City of Ramsey
Agenda
Environmental Policy Board (EPB)
Monday, March 15, 2021
6:30 pm
Council Chambers, 7550 Sunwood Drive NW

Consider Landscape Plan for Bunker Lake Industrial Park Building 4 (Project #21-109); Case of PSD, LLC

**BUNKER LAKE INDUSTRIAL PARK
 BUILDING #4 SITE IMPROVEMENTS**

LANDSCAPE PLAN
 CITY OF RAMSEY, MINNESOTA

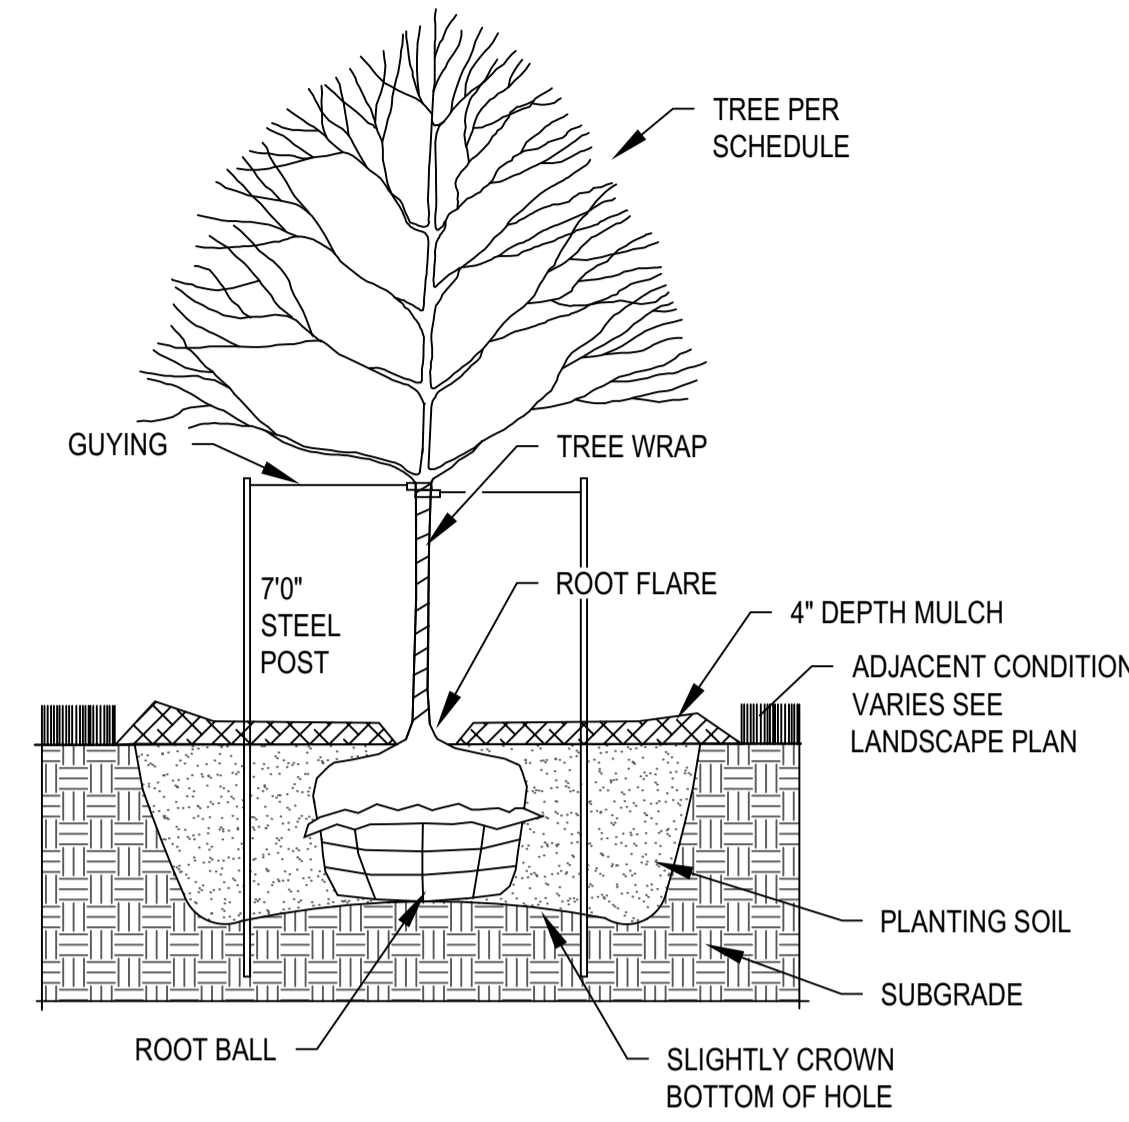
1 - Topsoil

Topsoil shall contain no more than 35% sand content. Amend Note 2 to specify this.

**PLANTING DETAILS &
PLANT SCHEDULE**
CITY OF RAMSEY, MINNESOTA

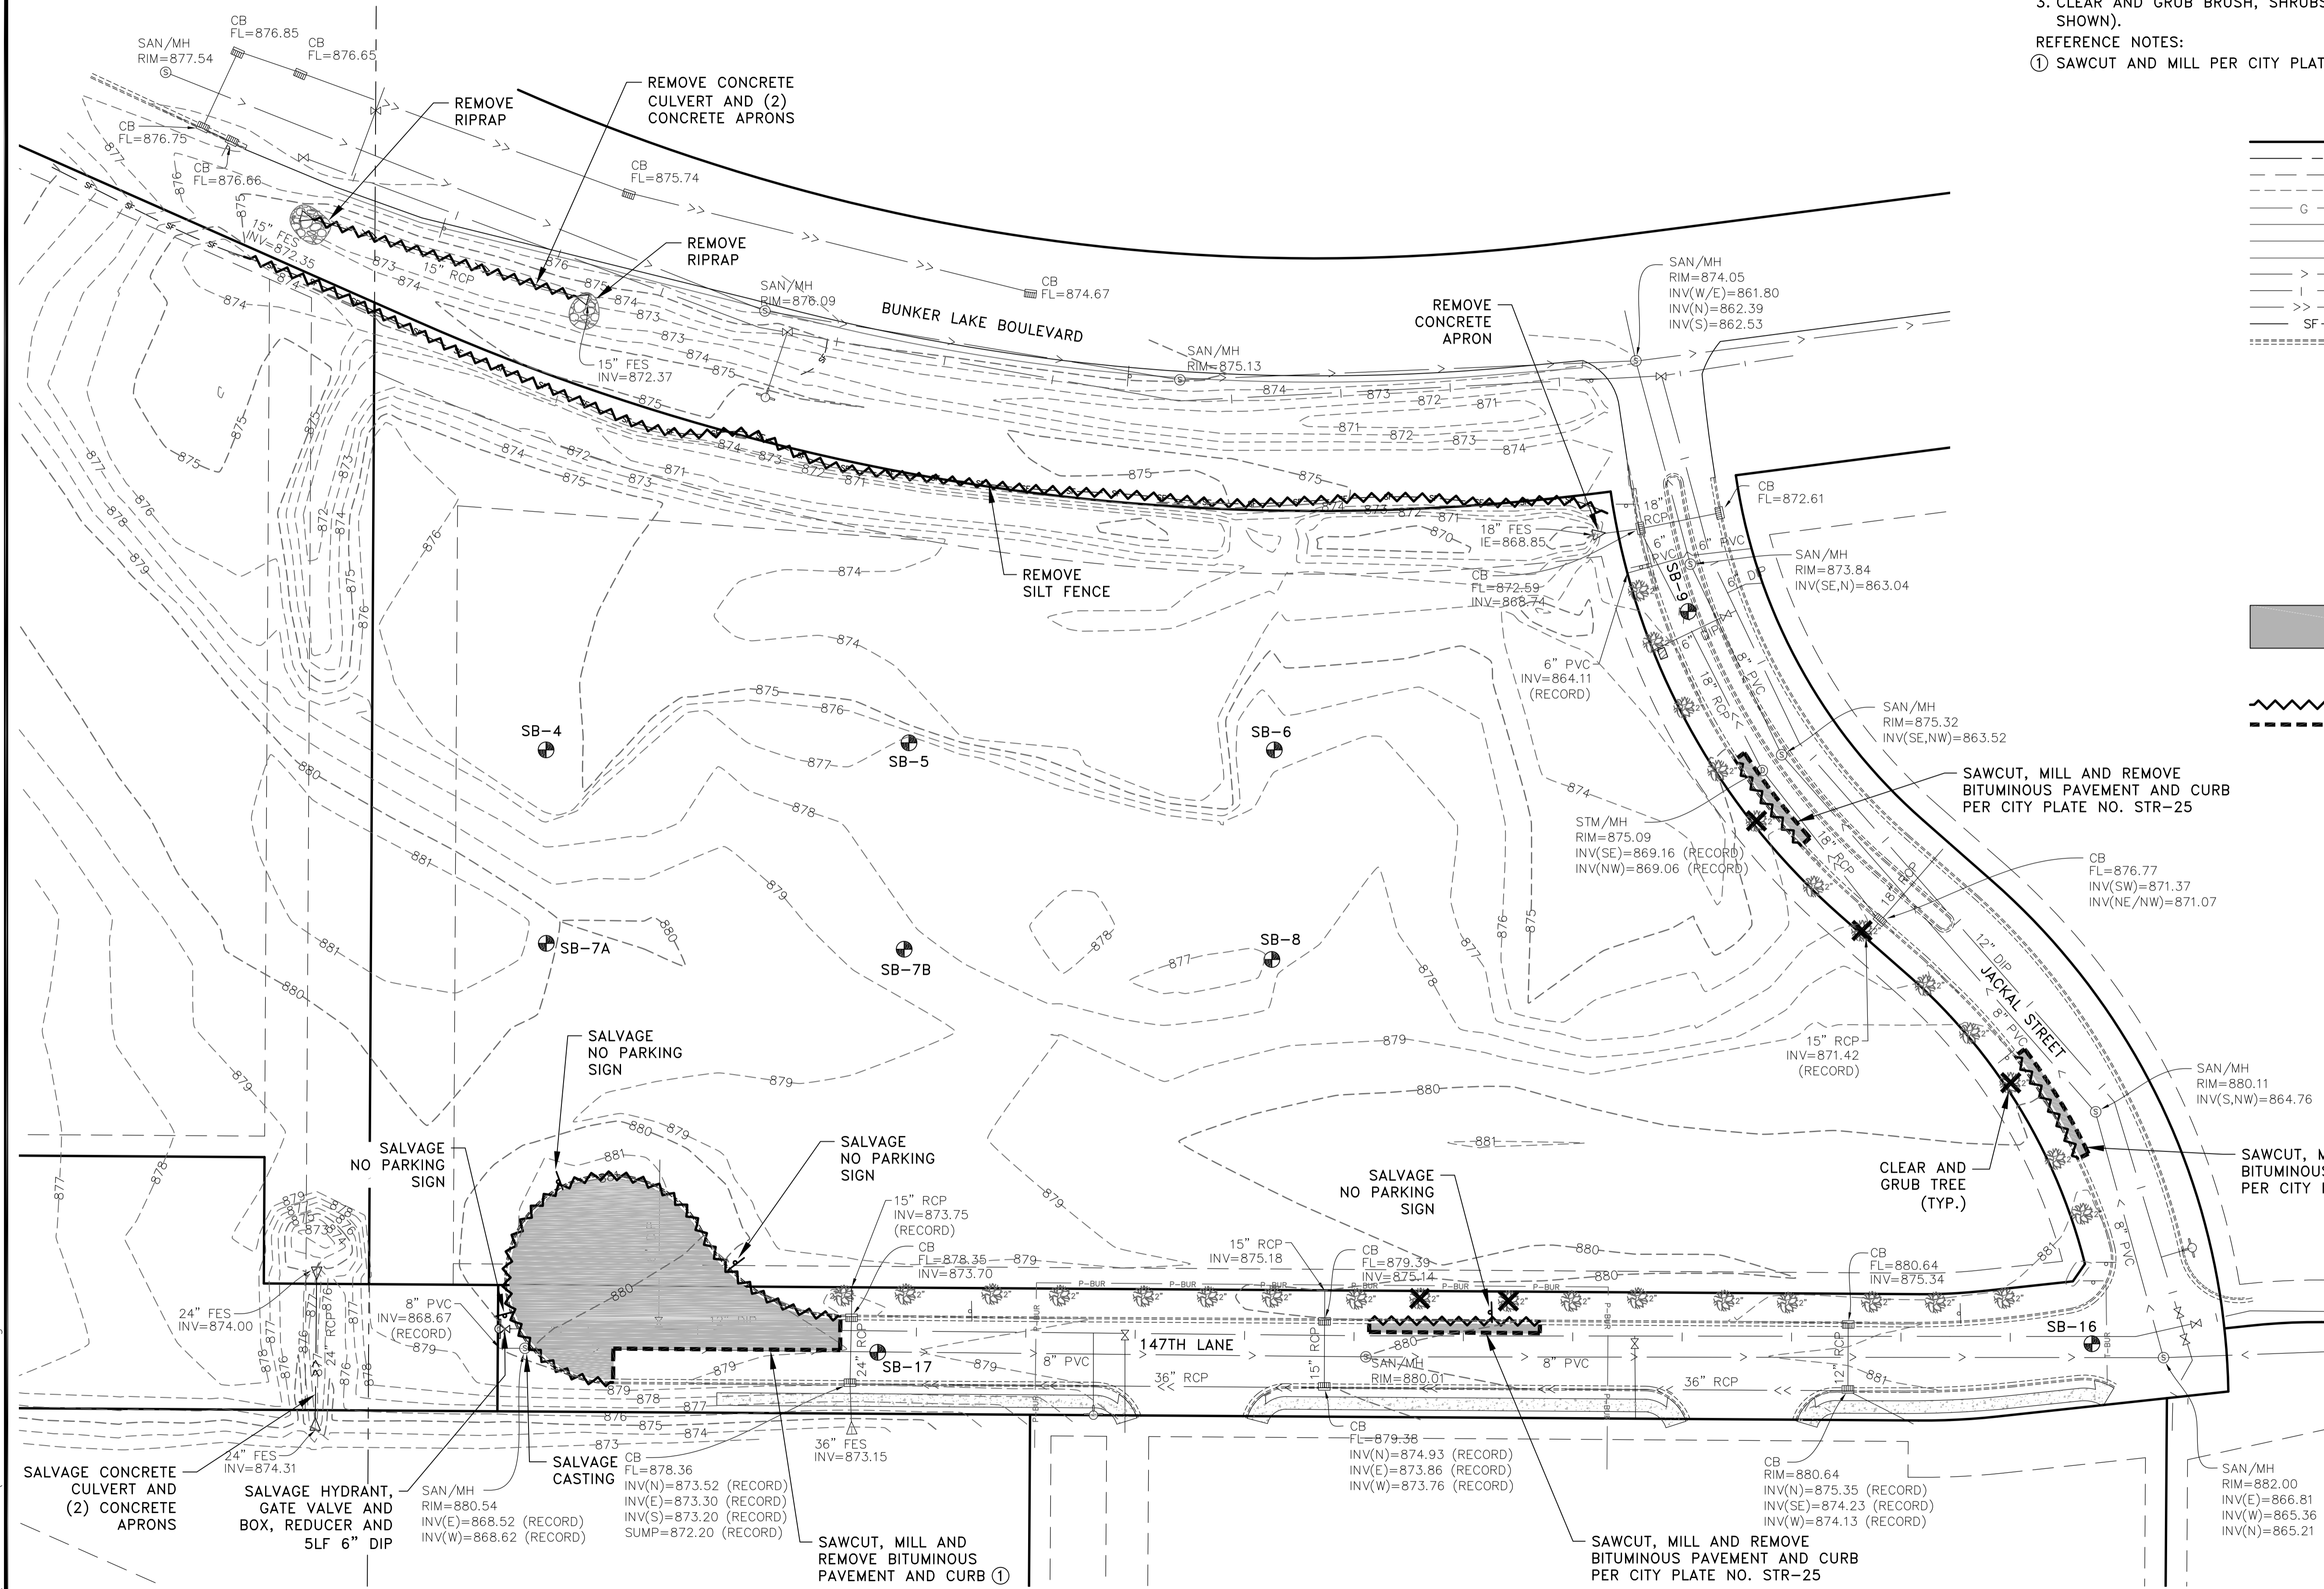
1 - Tree Sizes

Due to the reforestation requirements yet to be fulfilled for all of Bunker Lake Industrial Park (BLIP), consideration should be given to increasing the size of trees to account for more total caliper inches being installed.

**EXISTING TOPOGRAPHY
 AND REMOVALS PLAN**
 CITY OF RAMSEY, MINNESOTA

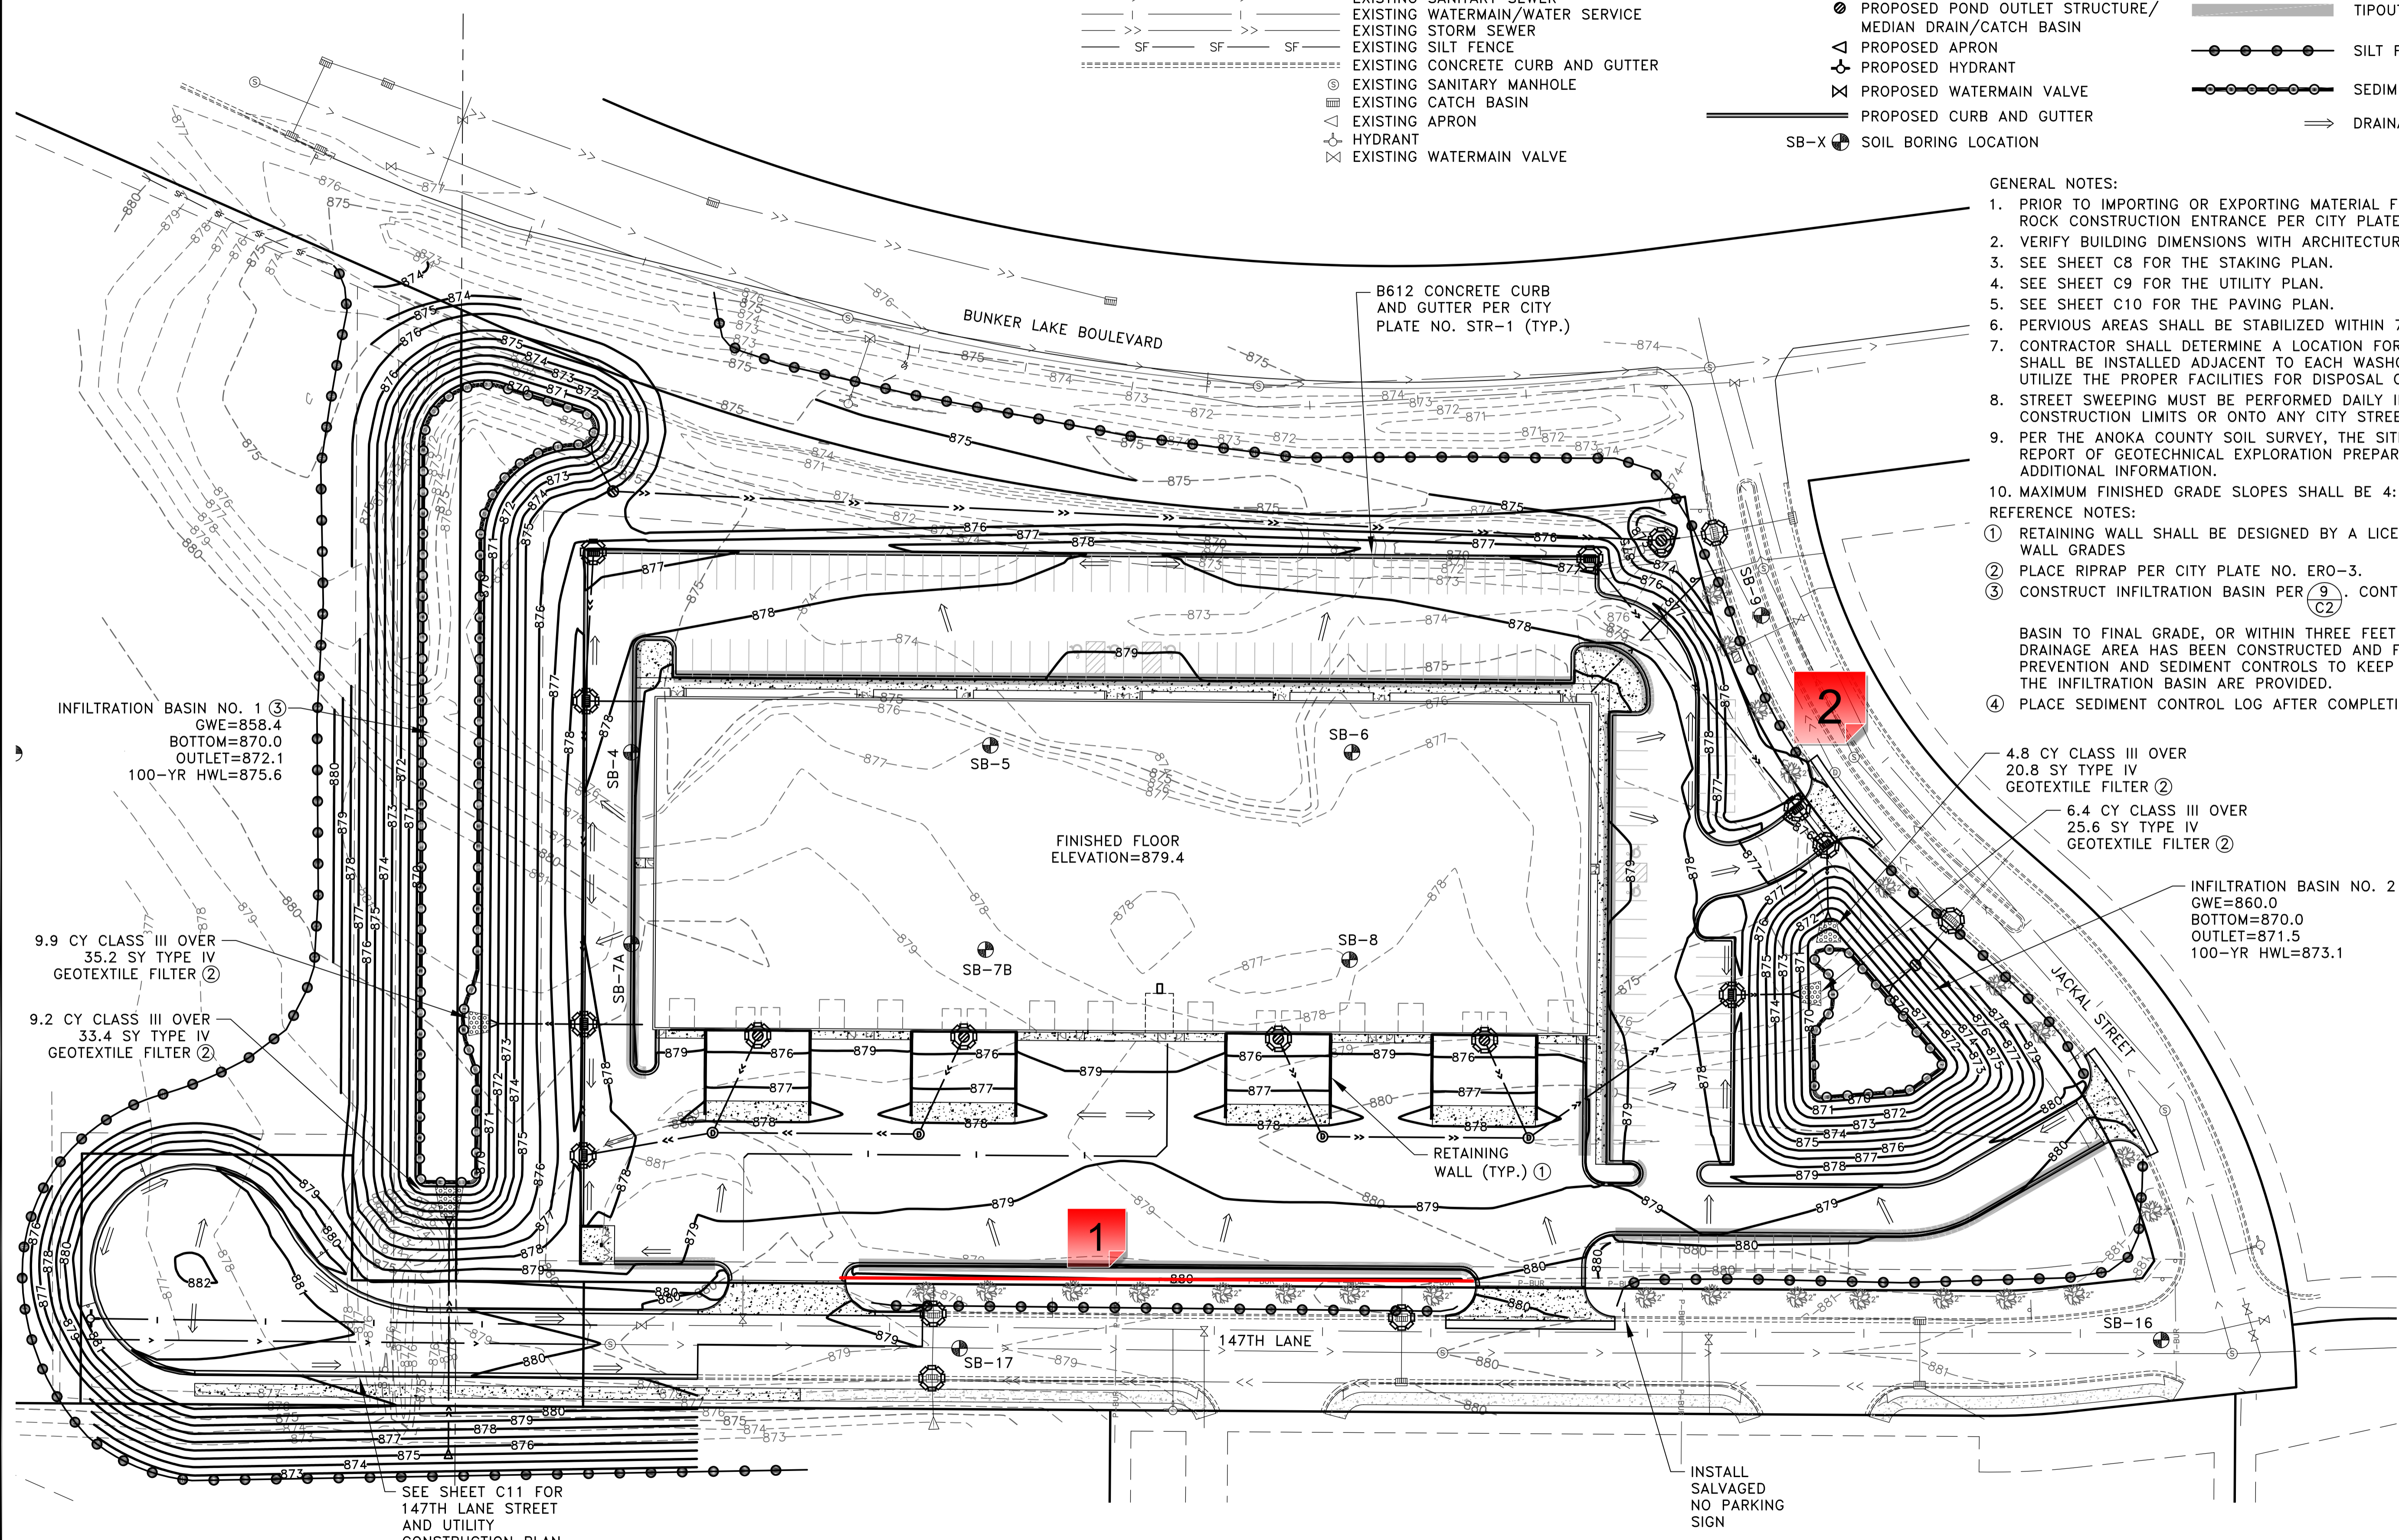
1 - Tree Save Fence

Need to add tree save fencing on the north side of boulevard trees as well to protect during construction of curb, gutter and asphalt work.

2 - Tree Save Fence

Either add additional tree save fencing on the west side of existing boulevard trees or adjust silt fence so it is west of trees to protect against grading activity.
